**SUBJECT: REVISION "A" TO TECHNICAL BULLETIN NO. 214ST-98-156
BELLMOUTH HEATER CIRCUIT, MODIFICATION OF,**

NO. 214ST-98-156

SUBJECT: BELLMOUTH HEATER CIRCUIT,
MODIFICATION OF

HELICOPTERS AFFECTED: Model 214ST S/N 28101 through 28200

214ST S/N 28101-28179
FIGURE 1

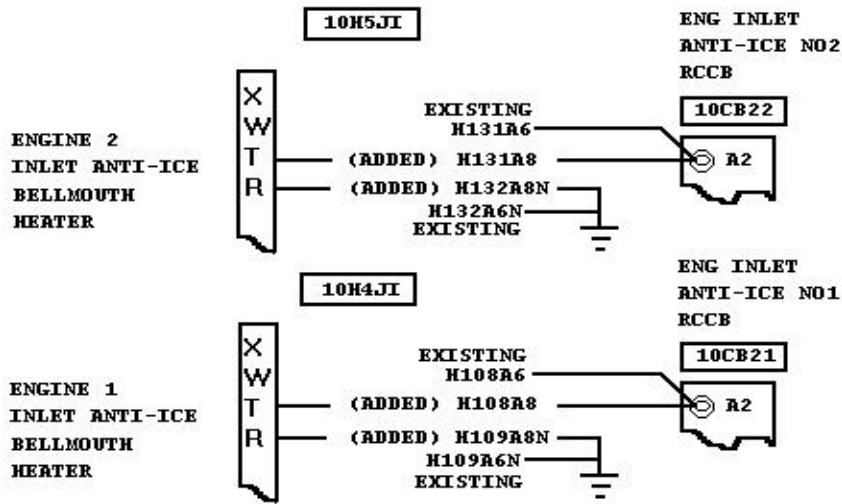
3. Refer to figure 1 of this Technical Bulletin and install added wires from the Engine bellmouth heater connectors to the Engine Anti-ice RCCB and to airframe ground.

If additional clearance is required at the aft electrical compartment bulkhead, Stuffing Tubes P/N G1338-A-4 may be removed and replaced with Plastic Grommet P/N MS21266-1N. Install plastic grommet with adhesive P/N 299-947-107 TY2 CL4.

214ST S/N 28180-SUB
FIGURE 2

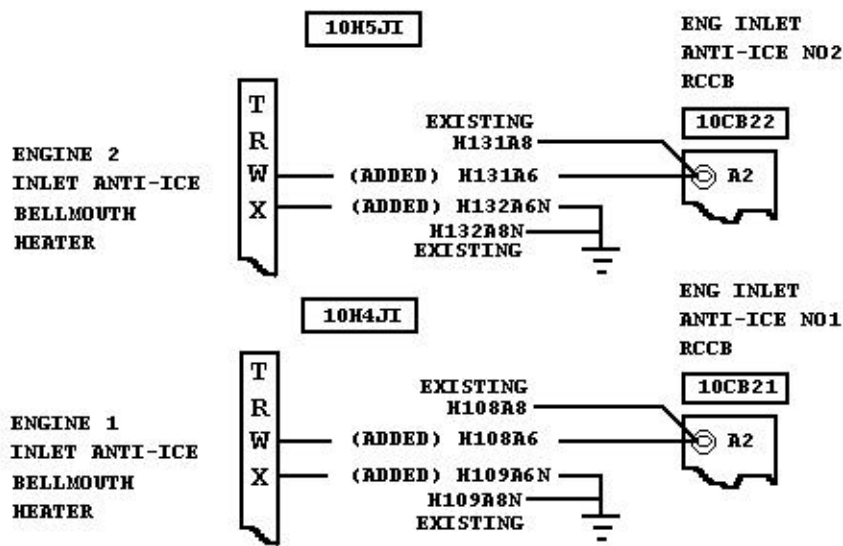
3. Refer to figure 2 of this Technical Bulletin and install added wire from the Engine bellmouth heater connectors to the Engine Anti-ice RCCB and to airframe ground.

If additional clearance is required at the aft electrical compartment bulkhead, Stuffing Tubes P/N G1338-A-4 may be removed and replaced with Plastic Grommet P/N MS21266-1N. Install plastic grommet with adhesive P/N 299-947-107 TY 2 CL 4.
